ADDENDUM

07PR0361

JHM, LLC  
(JHM, LLC)

REQUEST: Approval of a variable reduction to a 100 foot buffer in conjunction with site plan approval.

A.3  
Elevat  
Front ar

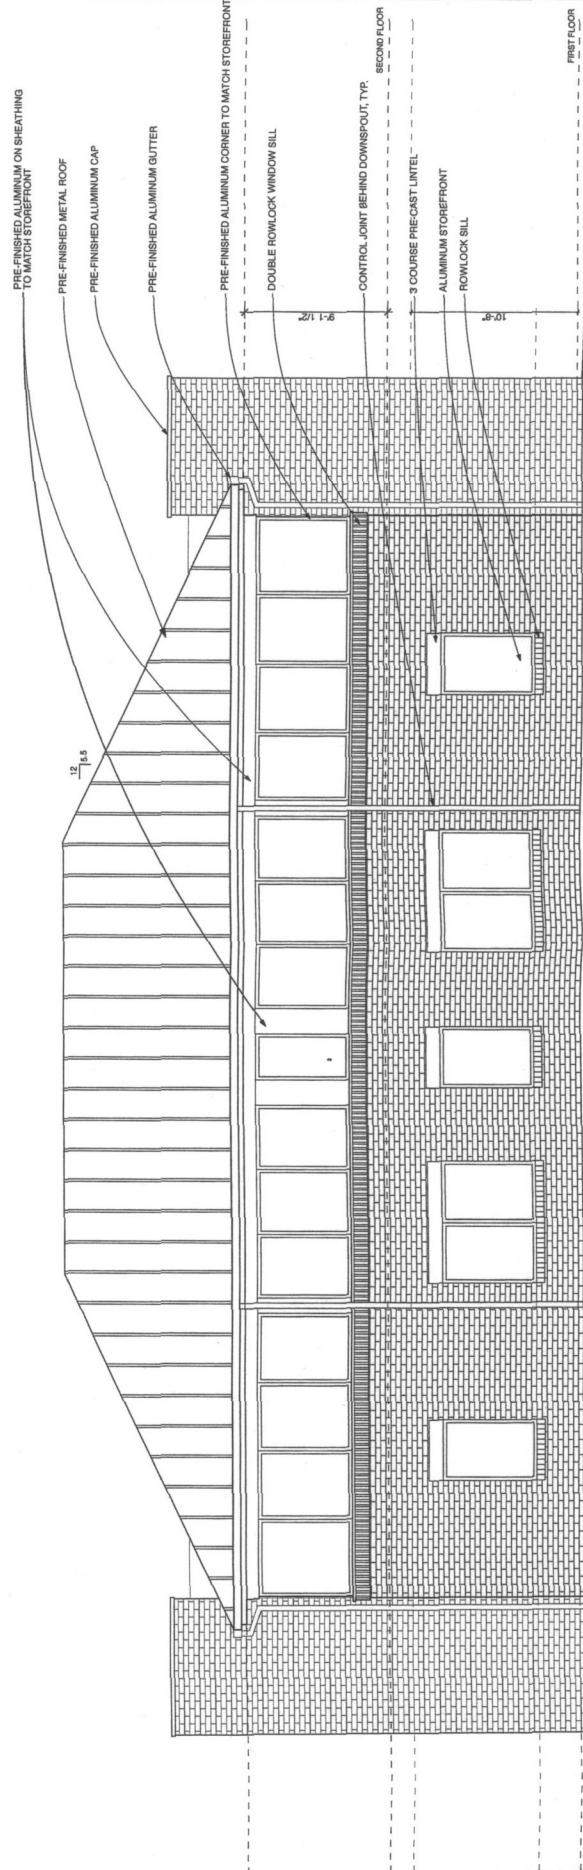
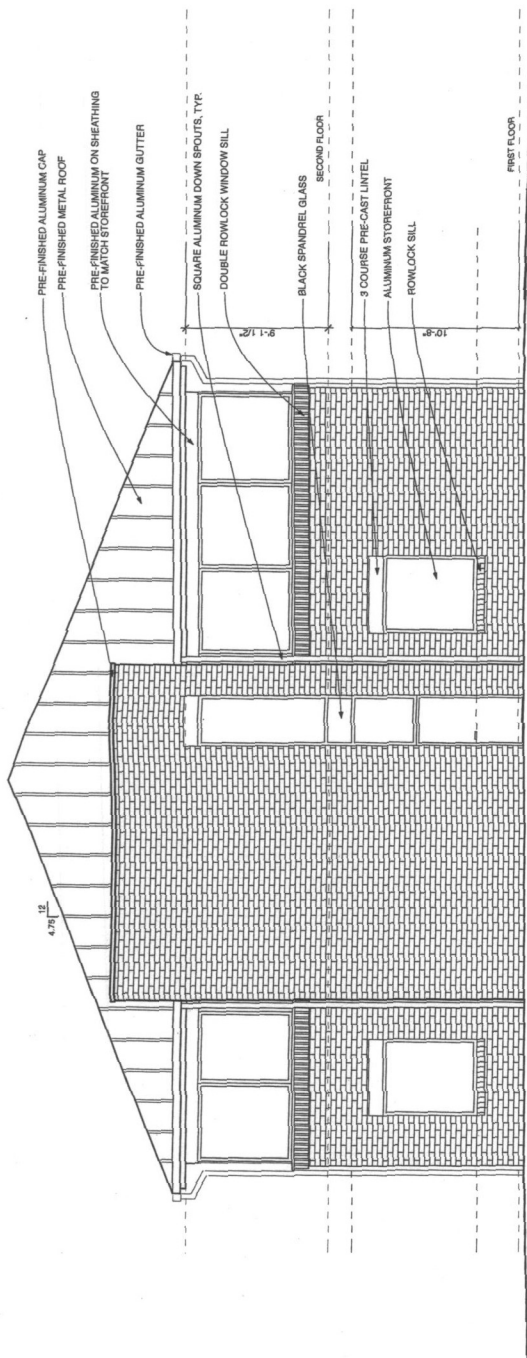
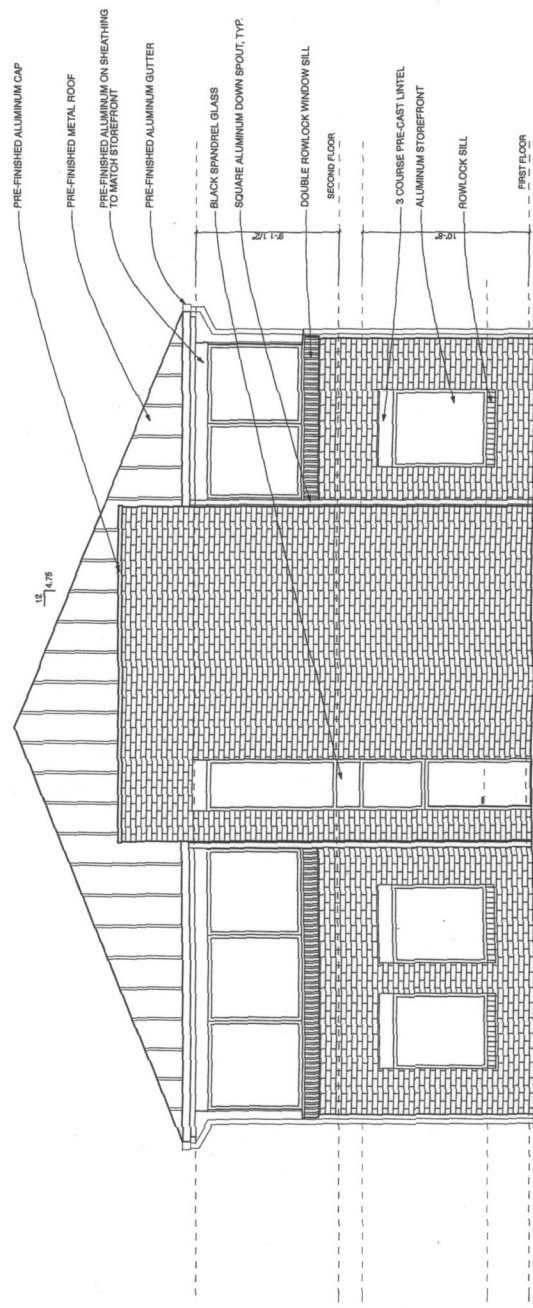
23. Building elevations have been provided for the office building with no staff comments. Also provide elevations for the maintenance building. See previous Comment 14 for additional information. (P)
24. The adjacent parcel 774-680-1836 to the north is not shown on the plans. Per previous Comment 19, show the owner, GPIN and current zoning for all adjacent parcels. Including this parcel will also revise the configuration of parcel 774-680-0947, which as shown does not match county GIS information. (P)
